Reply to Reviewer #1: *Stephen Wilson*

Adaption of the MODIS aerosol retrieval algorithm by airborne spectral surface reflectance measurements over urban areas: A case study

MS No.: amt-2015-139

Fig. 1: New version of Fig. 5 (old manuscript).

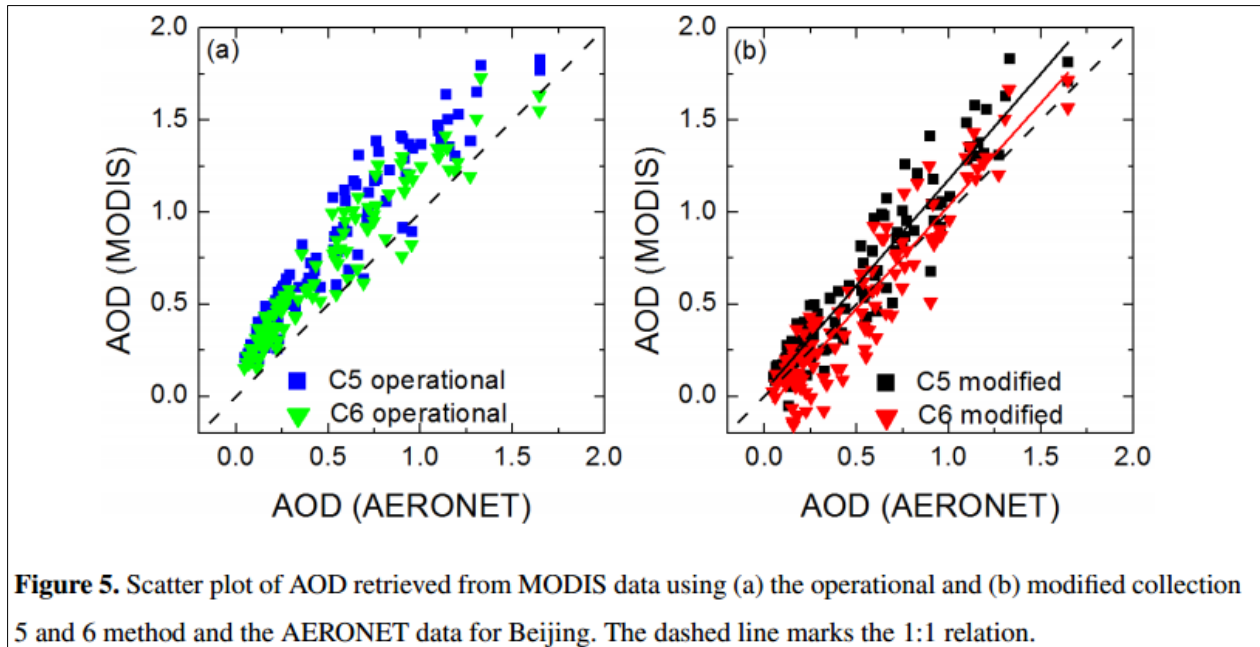
- Is it possible to generally improve the retrievals over urban areas without heavy tuning to each and every site? To apply the measurements to Beijing the authors limited their analysis to 6 months of the year and a restricted sza. Was this necessary? What magnitude are the errors introduced if these restrictions are removed?

Thanks for this question. Our original intention was to minimize retrieval uncertainties due to the surface assumption by selecting data with respect to viewing geometry and season. We expected larger variability of the slope parameter for the winter months (different vegetation) and for sensor zenith angles different from nadir direction (BRDF dependence). However, in the new version of the manuscript we used an extended set of MODIS data between 2010 and 2014. The mean difference of the adapted C6 method was improved, whereas for the modified C5 method nearly similar results were found. For this reason we changed Fig. 5 and the discussion of the Beijing-comparison as follows:

"Figure 5 presents the scatter plot and regression lines of the relation between AOD derived from MODIS versus measured by AERONET. Recall that when the retrieval expects a dark surface, a larger observed TOA reflectance is interpreted as enhanced aerosol contribution. Both operational algorithms systematically overestimate the AOD as compared to AERONET, which is consistent with urban surfaces being brighter than expected. However the C6 version is less biased. Since the operational C6 equations include a larger slope parameter $a(\text{NDVI}0.65/2.1)$ than does C5, the estimated surface reflectance is larger, leading to reduced retrievals of AOD. Using the measured $a(0.47/0.65)$ -spectral slopes in place of either C5 and C6-assumed slopes will further reduce retrieved AOD. Both modified methods show a reduction of mean differences between AOD(AERONET) and AOD(MODIS) as displayed in Table 3. However, while the mean bias is reduced in either version, modifying the measured slopes also leads to retrieval of negative AOD values, as shown in Fig. 5. Modifying the C6 version, which already had reduced bias compared to C5 operational version, tends to lead to even more retrievals of negative AOD. At the same time, the AOD standard deviations have increased (from 0.12 to 0.17) when using the modified C6 algorithm. One of the reasons might be the different sensitivity of TOA reflectance on changes of AOD over bright and dark surfaces. Over dark surfaces (as assumed in the operational retrieval), changes of AOD result in larger changes of TOA reflectance than over bright urban surfaces (as assumed in the modified retrieval). Consequently, measurement uncertainties have a larger effect on the retrieval uncertainty for an urban surface."

Fig.2: (a) Scatterplot of surface reflectances at 0.65 and 2.9 μm . (b) Wavelength dependence of mean surface albedo.

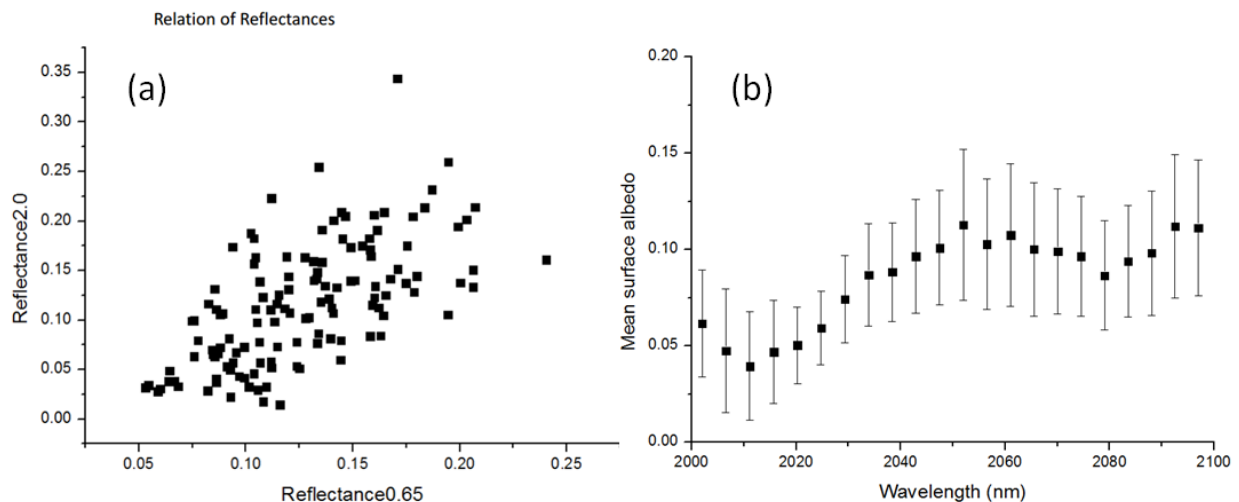
Secondly, you do not have measurements at 2.1 μm . However, you have values just below 2.0 μm . Your modelling shows that there is not great variability at these wavelengths. Why have you not looked at (say) 1.95 μm vs 0.65 to at least test the stability of Equation 2? It may be that the S/N is not good enough?

Fig. 2a shows the scatterplot of the surface reflectances at 0.65 and 2.0 μm as derived from aircraft measurements. We used some mean value of this poor correlation ($R=0.62$) for the adapted retrievals but it didn't improve at all. Furthermore, since we have more reliable data of the surface albedo we have plotted the mean spectrum between 2.0 and 2.1 μm calculated for measurements along the flight path over Zhongshan (Fig. 2b). It shows that at least for the surface albedo the surface reflection property at 2.0 μm differs from that at 2.1 μm . Therefore we did not apply a new slope assumption for 2.1 versus 0.65 μm for the adapted retrievals.

“According to Eqs. (2) and (3) the surface reflectance at 0.47 μm wavelength in the MODIS AOD algorithm is derived from that at 0.65 μm based on the surface reflectance at 2.1 μm . The airborne measurements of the surface reflectance are not reliable for wavelengths larger than 2.0 μm , due to the low sensitivity of the albedometer. The relation between reflectances at 2.0 μm and 0.65 μm cannot be used as approximation to modify Eq. (2) because of the strong differences between 2.0 and 2.1 μm , and the finding that reflectances at 2.0 μm and 0.65 μm are poorly correlated ($R=0.62$).

Therefore, our strategy is to modify only the blue/red fit parameter of Eq. (3) to match the airborne observations above Zhongshan.”

Fig.3: Examples of LIDAR profiles of extinction. Values below dotted lines are extrapolated.

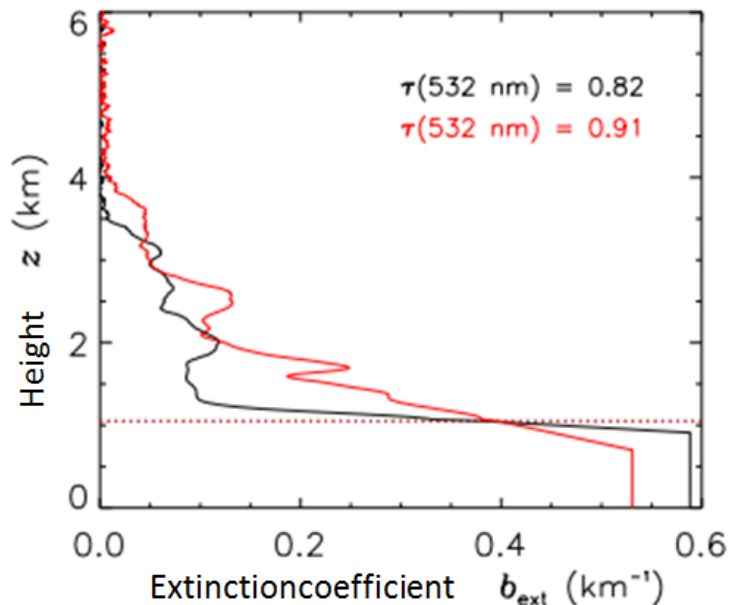
P7343 L12 -> It took a while to decipher this paragraph, and as written it is still not a constrained problem I believe. I cannot see how the extinction of the well-mixed layer is set. Is it presumed that it has the value at the top of the layer above? Please clarify.

We have rewritten the paragraph. For further explanation (not shown in the manuscript) examples of the extinction profiles are shown in Fig. 3. It should clarify the procedure for the extrapolation.

“Since the LIDAR did not provide information on the vertical aerosol distribution up to 1000 m height, the vertical extinction profile was extrapolated from 1000 m to the surface in correspondence with the vertically integrated extinction coefficient (AOD) of the Sun photometer. The layer between surface and 1000 m height was separated into two sub-layers. Starting from 1000 m altitude the extinction was assumed to increase with decreasing height following the measured slope of the LIDAR extinction profile. The second sub-layer with a constant aerosol extinction coefficient was assumed below to represent a well-mixed layer.”
